Minor Amendment to provide restricted parking signage along street frontages.

The purpose of this letter is to authorize Consensus Planning, Inc. to act as agents for Broadstone Highlands North, LLC for a Minor Amendment to the Site Plan – DRB for the Broadstone Highlands North project. The property is legally described as Tract 1, Plat of the Highlands, located at 200 Mulberry Street NE and containing approximately 2.4 acres.

The purpose of this letter is to request approval of a Minor Amendment to the Broadstone Highlands North Site Plan – DRB to provide for the installation of restricted parking signage around the site. The subject site is legally described as Tract 1, Plat of the Highlands containing approximately 2.4 acres and is located at 200 Mulberry Street NE.

## BROADSTONE HIGHLANDS NORTH

## A1.10

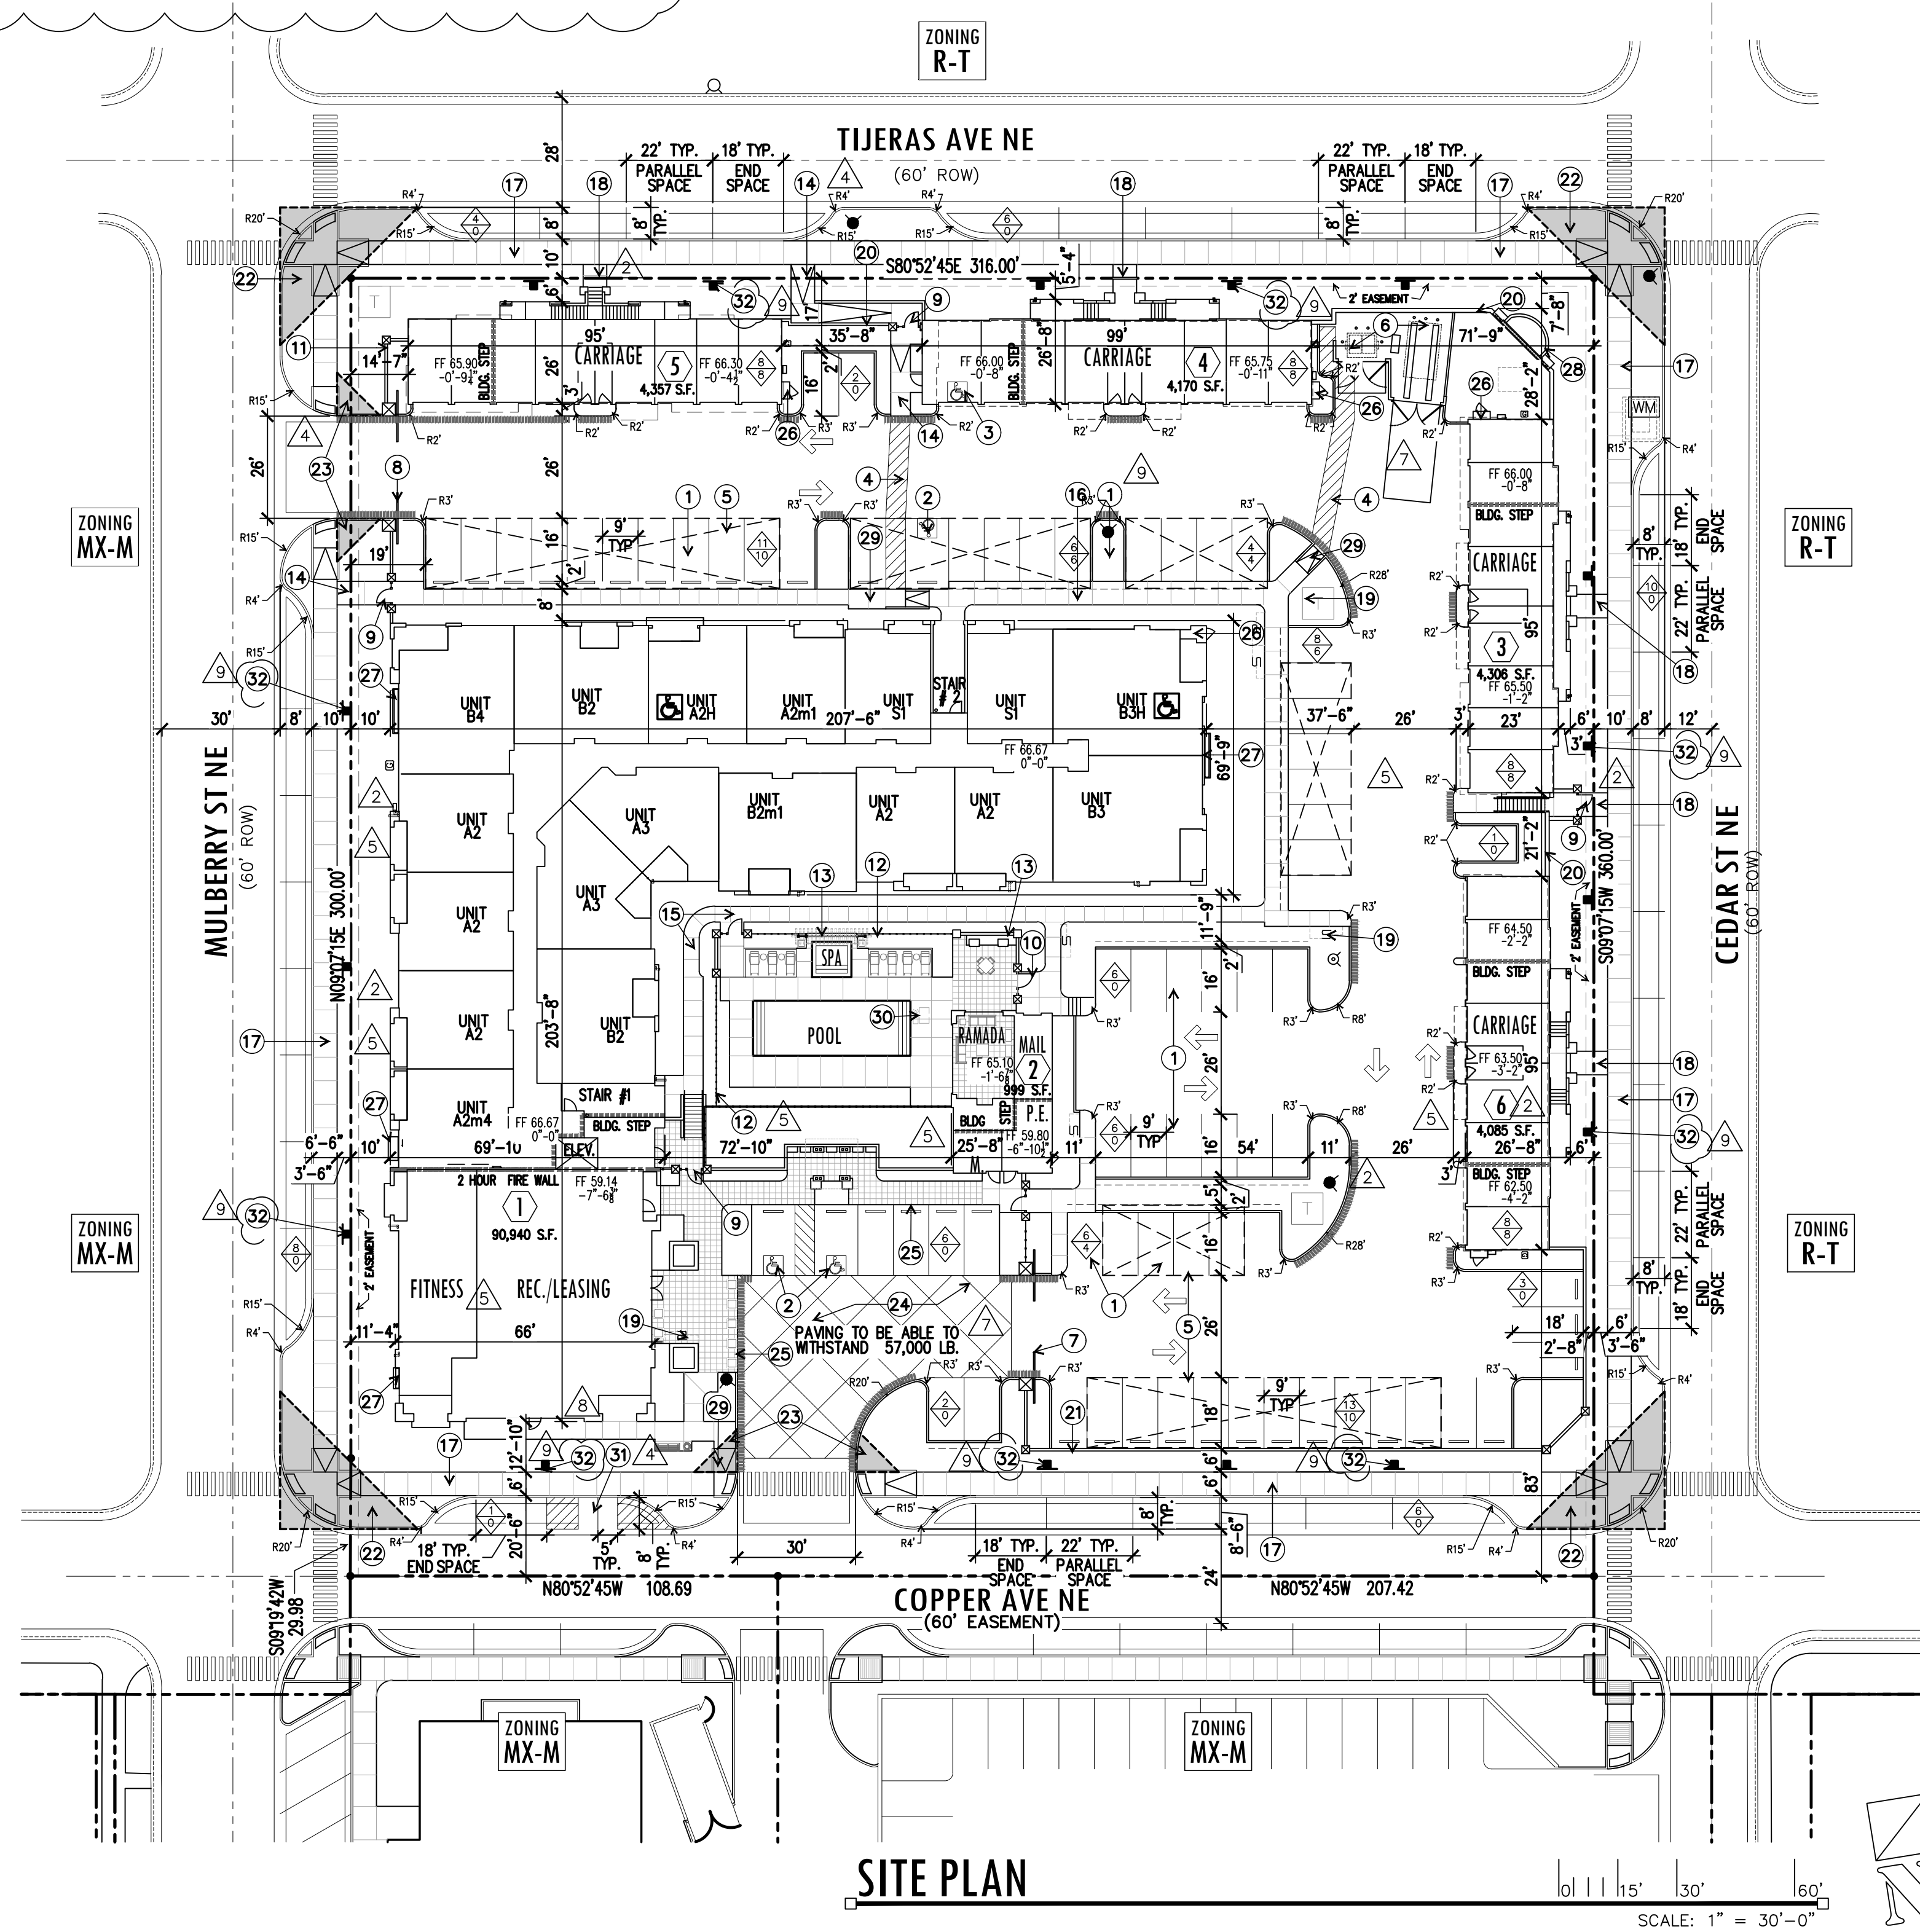
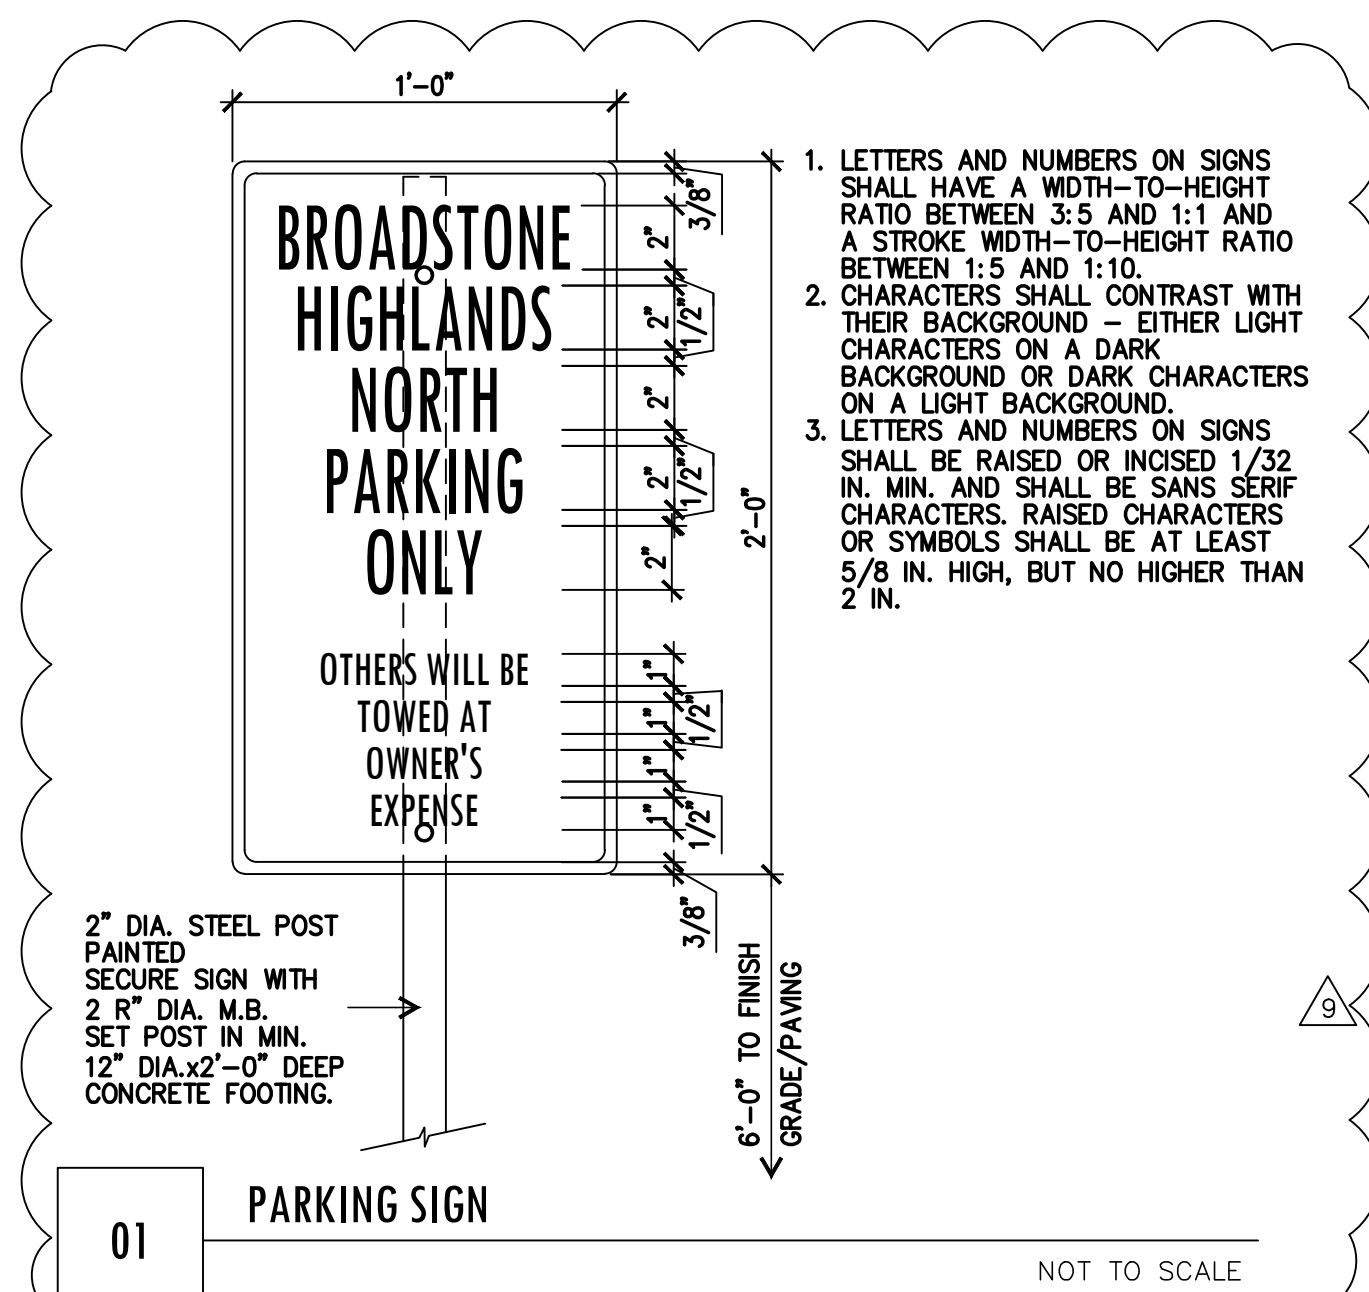
The attached amended site plan shows the proposed sign locations with a new keynote #32 with the associated detail shown in the upper left corner (01/A1.10). This amendment meets the criteria to be considered a minor amendment under Section 14-16-6-4 (Y)(2)(a) of the IDO based on the following (Applicant responses following each criterion in italics):

33. BROADSTONE HIGHLANDS NORTH PARKING ONLY SIGN LOCATION, PER DETAIL 01/A1.10
